STAFF REPORT
Department of Planning and Building Services

TO: Fairfax Planning Commission
DATE: August 19, 2021
FROM: Ben Berto, Director of Planning and Building
LOCATION: 403 Cascade Drive; Assessor's Parcel No. 003-044-10
ZONING: Residential Single-family RS-6 Zone
PROJECT: Construction of a new single-family residence
ACTION: Use Permit and Design Review Permit; Application # 21-10
APPLICANTS/OWNERS: Jon Fernandez/Fernandez S2 Partnership Architecture
CEQA STATUS: Categorically exempt, §15303(a)

403 CASCADE DRIVE

A Resolution of the Fairfax Planning Commission Approving a Design Review Permit and Use Permit for a New Residence at 403 Cascade Drive

ATTACHMENT C

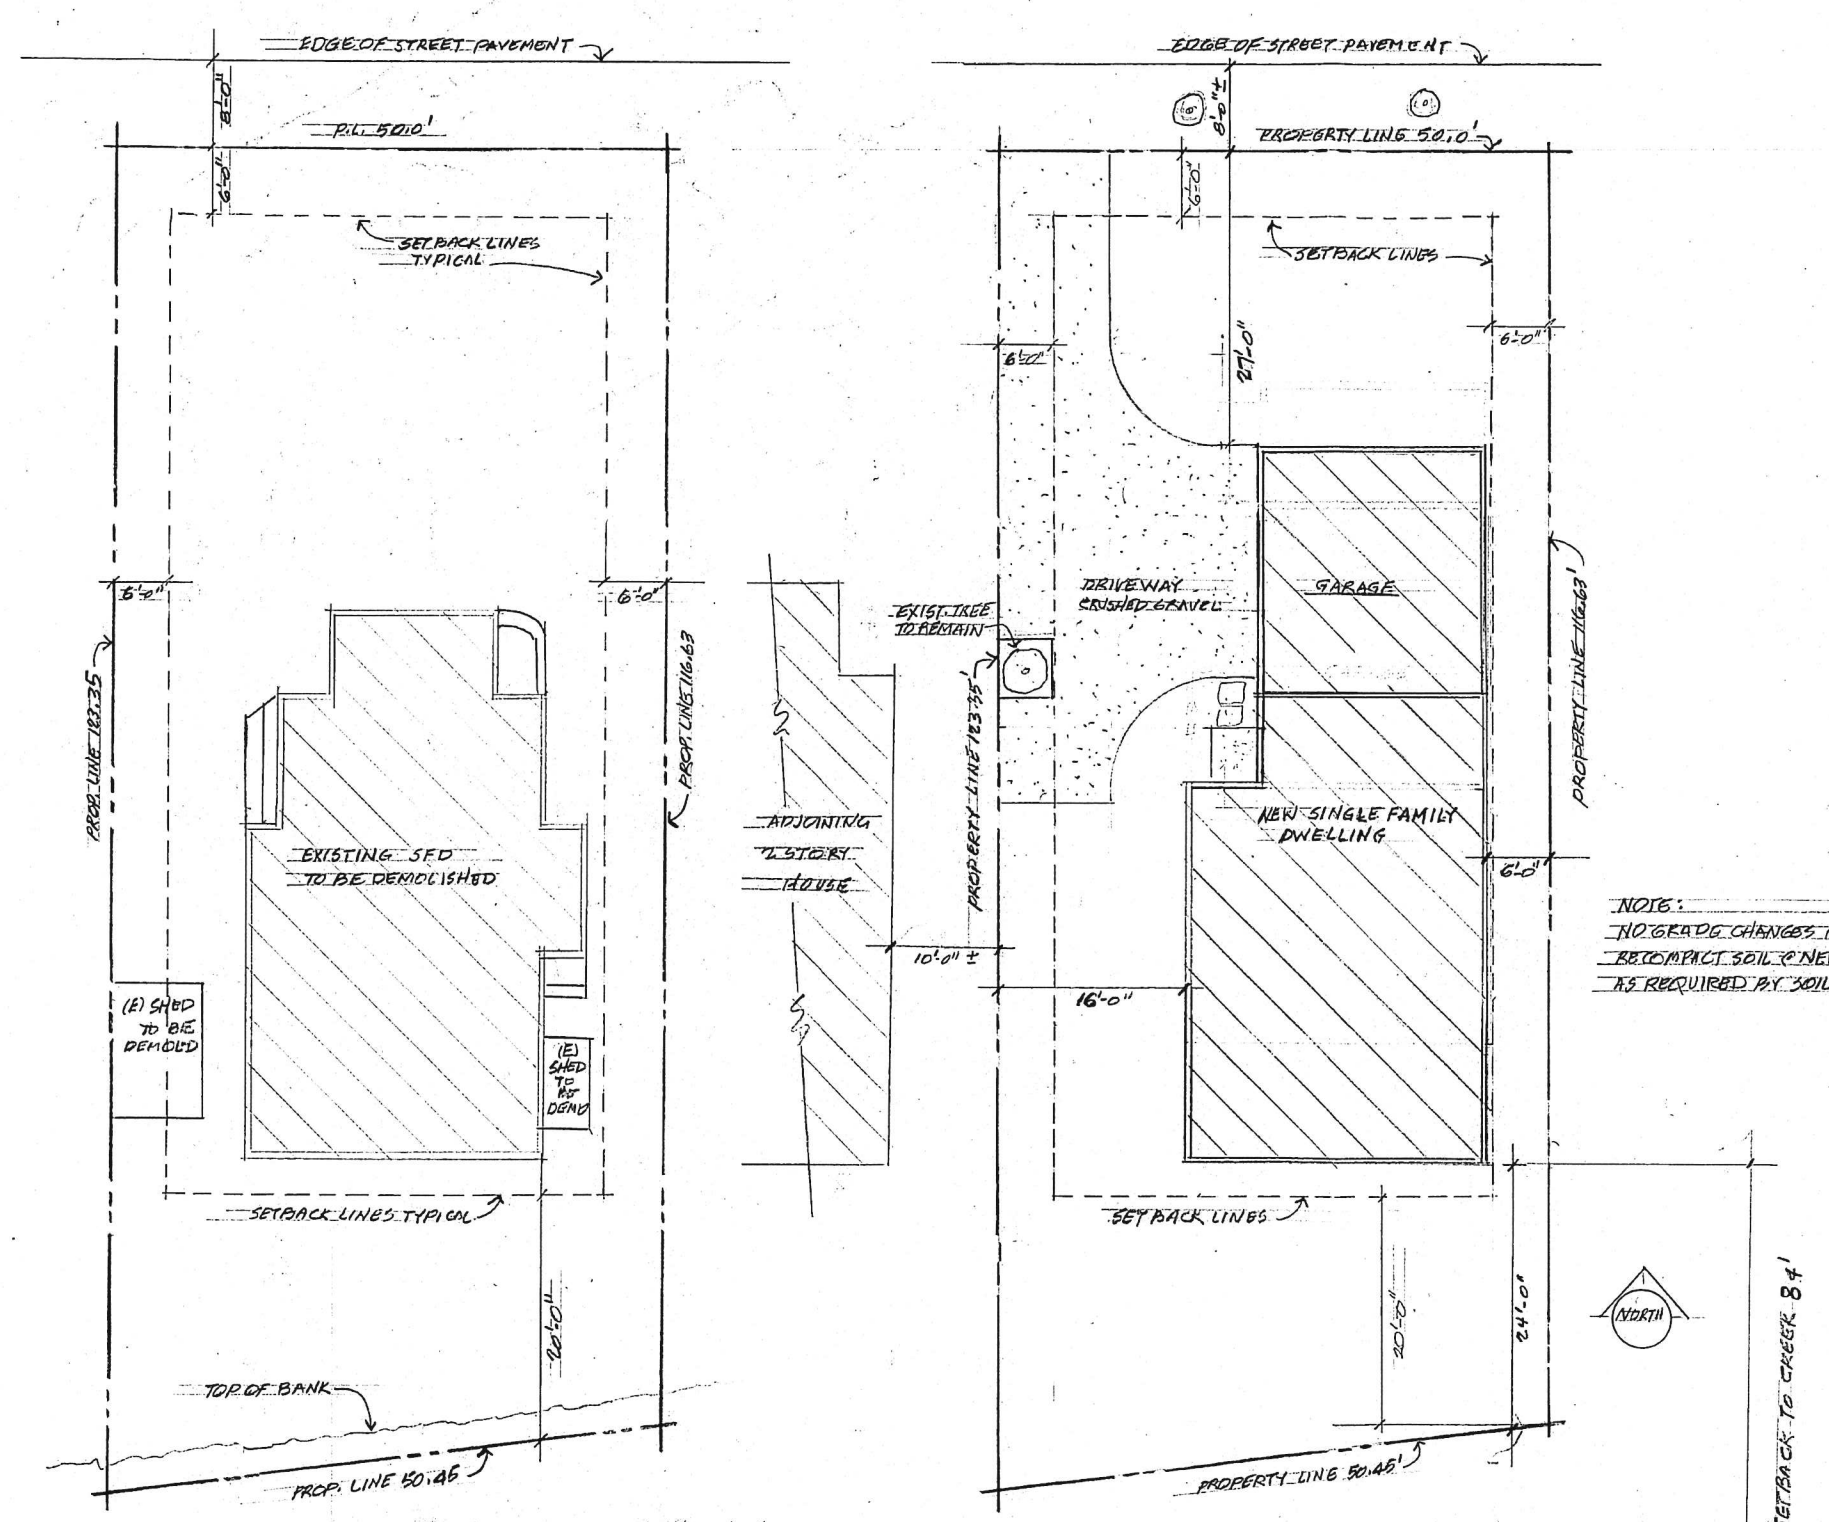
The applicant was also requested to provide additional information regarding impervious site coverage.

A landscaping and drainage plan has also been provided, showing Ceanothus plants in front of the garage and providing adequate street screening. In response to a Commissioner’s request, the applicant has included site coverage information on the site plan (see Attachment C)

EXISTING SITE PLAN - 1/8"=1'-0"
 TOTAL IMPERVIOUS AREA - 1123 SQ. FT.
 TOTAL PERMIMBLE AREA - 4877 SQ. FT.
 PARCEL SIZE - 6000 SQ. FT.

REVISED SITE PLAN - 1/8"=1'-0"
 TOTAL IMPERVIOUS AREA - 1686 SQ. FT.
 TOTAL PERMIMBLE AREA - 4314 SQ. FT.
 PARCEL SIZE - 6000 SQ. FT.
